# 1100 NW 54TH ST

3033670-LU // REC PROPOSAL // ADMINISTRATIVE DESIGN REVIEW  
25 JUNE 2020

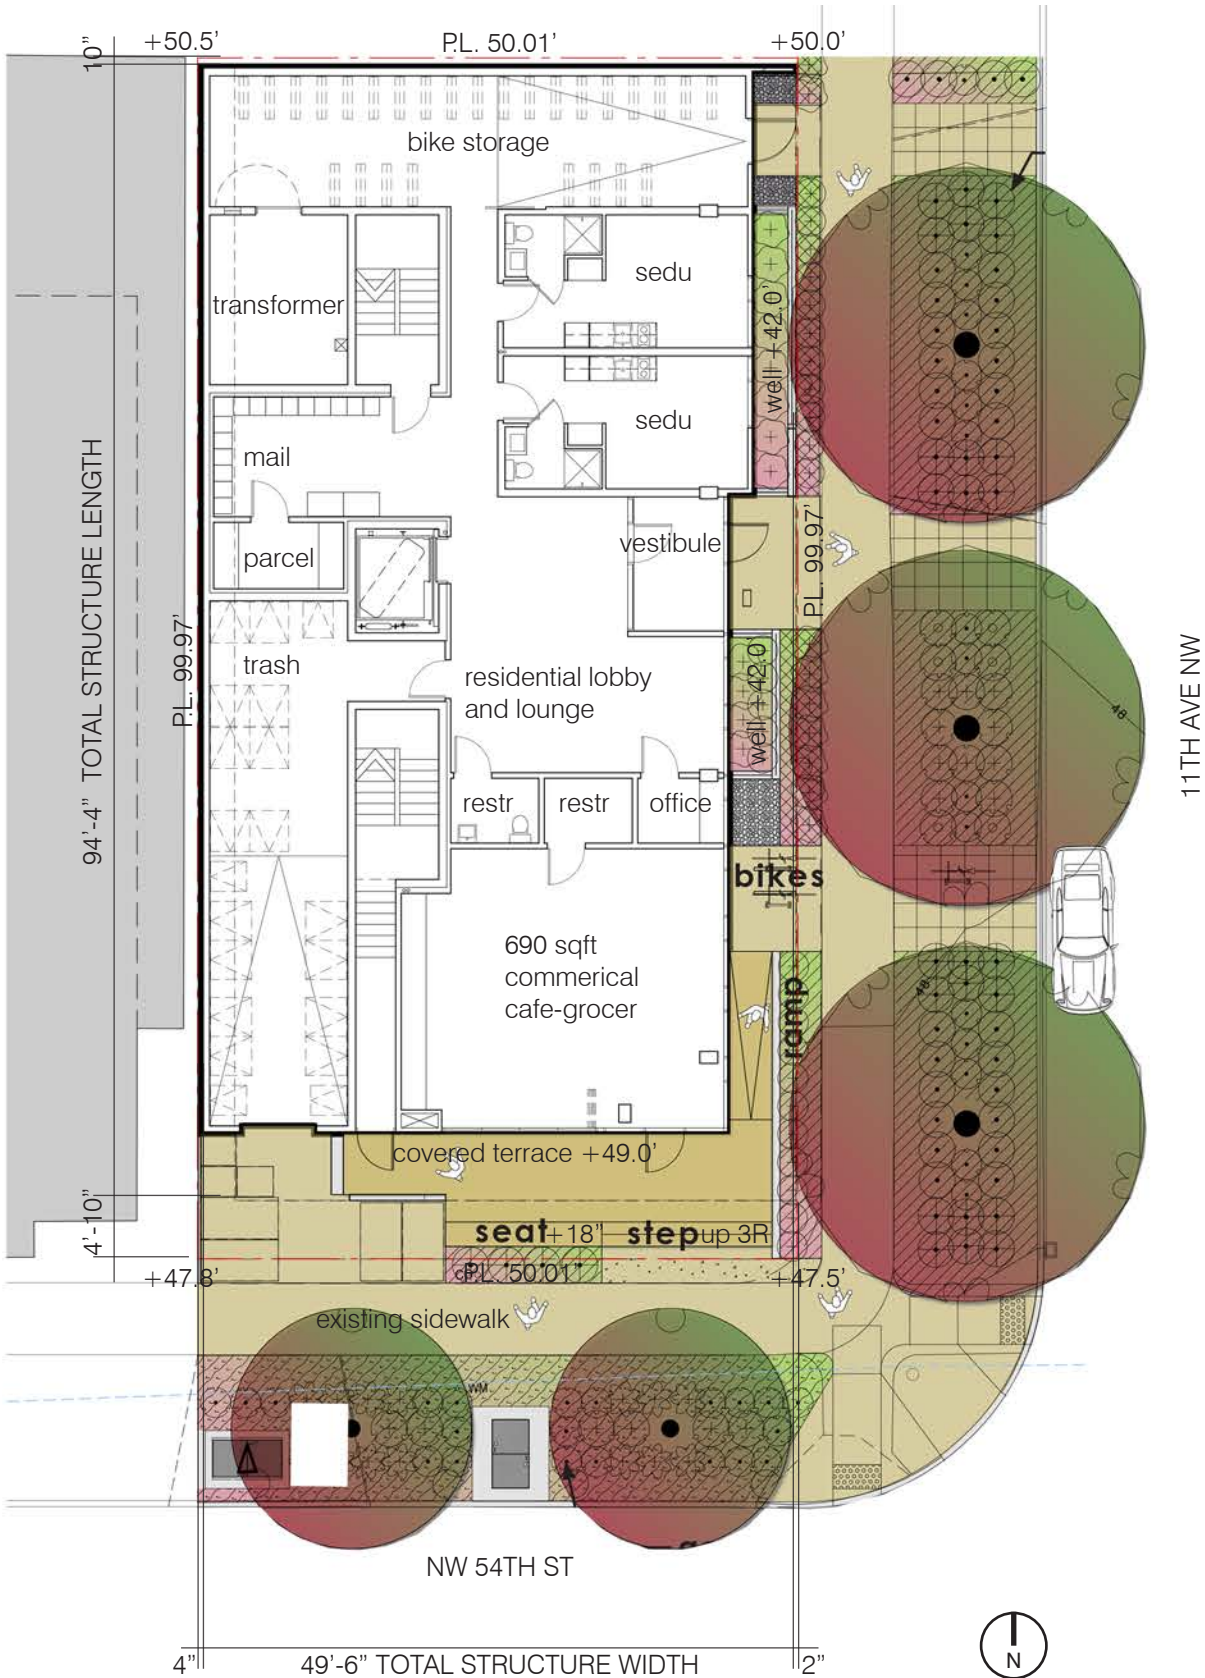
*b. The Board stated that the ground-level of the east façade needed further development, suggesting additional design be centered around the residential tower entry location. The Board requested the design team explore methods to incorporate some of the tower materiality into this façade and other elements (i.e. the fin of 54th abutting the trash staging area, signage, etc.) with the goal to add more character and texture. (DC2.B, DC2.C, DC2.D, DC4.B)*

c. The Board agreed with public sentiment that any future guardrails or metal grating lids for the light wells should be integrated with future landscaping to enhance the streetscape. Demonstrate the design and location of any proposed light well security measures, as well as enhancements, at the Recommendations stage to review. (PL3.B, DC2.C, DC4.D)

d. In reviewing the accessible ramp abutting 11th Avenue Northwest, the Board requested the applicant investigate the possibility of not installing handrails that may detract from the building's appearance at the streetscape level. (DC2.C, DC4.A, DC4.D)

*Response b. Similar to the south fin wall along the 54th street frontage, the design proposes a wall element to define the residential lobby entrance on the east side. This extends the massing of the tower to the ground and scales the longest façade of the project. This also differentiates the more public commercial use and residential entry lobby from the street level dwelling units to enhance the privacy for those units. The wall plane is an ideal location for integrated building signage.*

Response c. The east edge of the light wells extends above grade to create a datum of pedestrian scaled concrete elements that provide a backdrop for landscaping between the sidewalk and the building. Open white metal guardrails around the lightwells provide protection, reinforce points of entry into the lobby and the bike room, and connect the street level to the upper level loggia rails through building element continuity. The guardrails, together with the landscaped edges, filter and layer between building activity and the sidewalk pedestrian movement.

Response d. The ramp has been extended in length so that the slope is shallow enough to avoid the ramp classification, therefore no handrails are required. To the north of this walkway along the commercial storefront edge the on-site short-term bike parking has been integrated into the sidewalk edge features for easy access between commercial and residential entries.

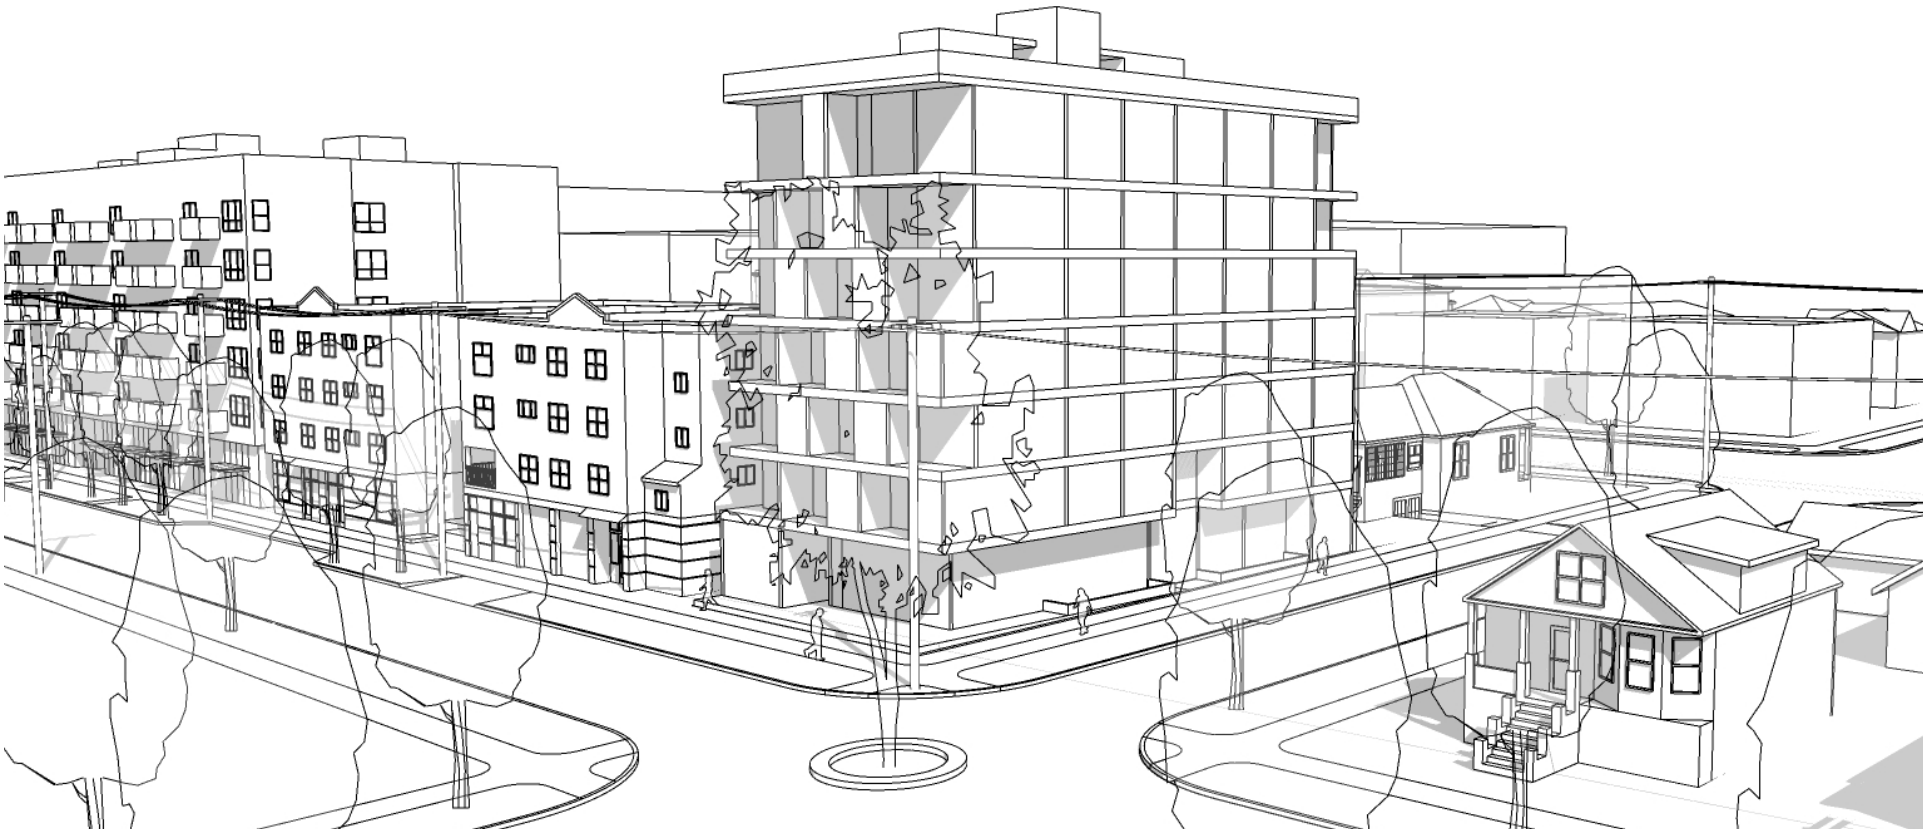
a. The Board reviewed each design scheme (“Stacked”, “One Step” and “Park Fabric”), considered public input and offered feedback. The Board swiftly dismissed Scheme A (Stacked) as a cohesive design for the project site and proceeded to apply focused design discussion about the two remaining design schemes (One Step (B) and Park Fabric (C)). The Board summarized that Schemes B and C did not effectively transition to the surrounding lower-scaled residential properties to the north and east. Thus, the Board directed the applicant to return for a Second Early Design Guidance meeting to further explore development of Scheme C with the following guidance, noting that the response could include alternate designs that meet the intent of this guidance:

i. The Board voiced strong support for the design concept of Scheme C (Park Fabric) illustrating the usage of loggias primarily applied to the design’s south façade with minor application of the loggias to the upper-levels of the massing’s north façade; and agreed that this architectural parti is an opportunity to provide connectivity to the existing park across from the project site. (CS2.B, CS2.C.1)

ii. The Board emphasized that the future massing should provide an appropriate transition to the Lowrise-zoned (LR3) properties east of the project site and the lower-intensity neighborhood commercial zoning (NC2-55) to the north. The Board articulated that Scheme C was the strongest design concept but the Board was very concerned with the height, bulk and scale of the massing form on 11th Avenue Northwest and its impact to the lower-scaled properties to the east. Thus, the Board directed the design team to address this concern in the next design iteration presented at the next EDG meeting. A design that illustrates an application of the loggia concept to the entire massing on both street facades wrapping to the upper-levels of the north façade would be considered a strong response to this guidance. (CS2.D)

**Response: Park Fabric has been further developed by distributing loggia on the south and east facades, along with the upper levels of the north facade. The concept scales the facade providing depth and activation to appropriately transition to the lower intensity zones. The design team studied the east side, particularly the northeast corner, and sculpted an alternating pattern of loggia into the facade. While the massing is substantially carved away along faces and at corners it maintains a primary cohesive form.**

Park Fabric north side

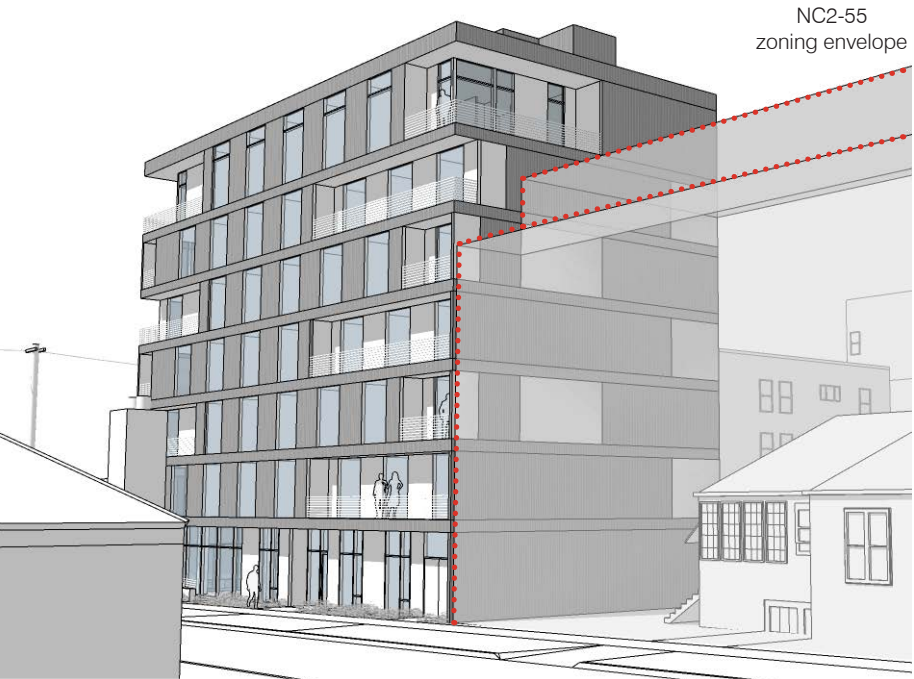
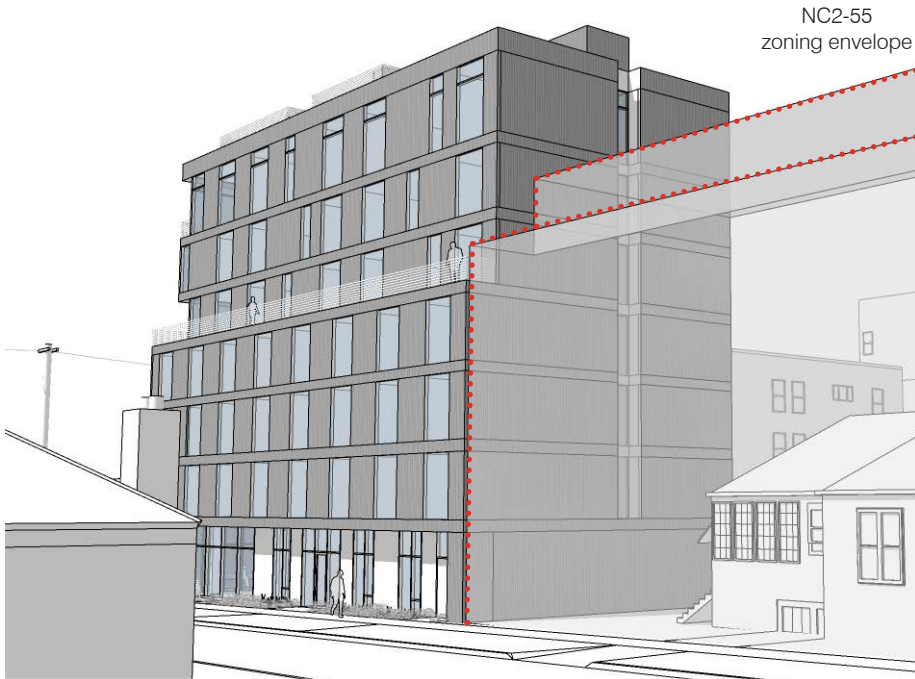
b. The Board discussed the treatment of the north façade which is a party wall. In reviewing the massing diagrams in the EDG design packet, the Board recognized that the visibility of a majority of this façade would be a temporary condition until future development occurs at the adjacent property north of the subject site (pg. 24). However, the Board also acknowledged that a portion of the upper-stories of the north façade would be permanently visible and stated that further study of the treatment of this portion of the facade is necessary as the building evolves. (DC2.A, DC2.B, DC2.C, DC2.D)

**Response:** The preferred option, Park Fabric, carves out the corner of level 6 and 7 continuing the loggia vocabulary onto the portions of the facade that will remain exposed above the future NC2-55 development. The remainder of the blank wall will utilize a siding pattern that corresponds to the graphic contrast of the shell & liner concept. This language is also carried around to the west facade. One Step utilizes a central corridor reveal to scale the north facade.
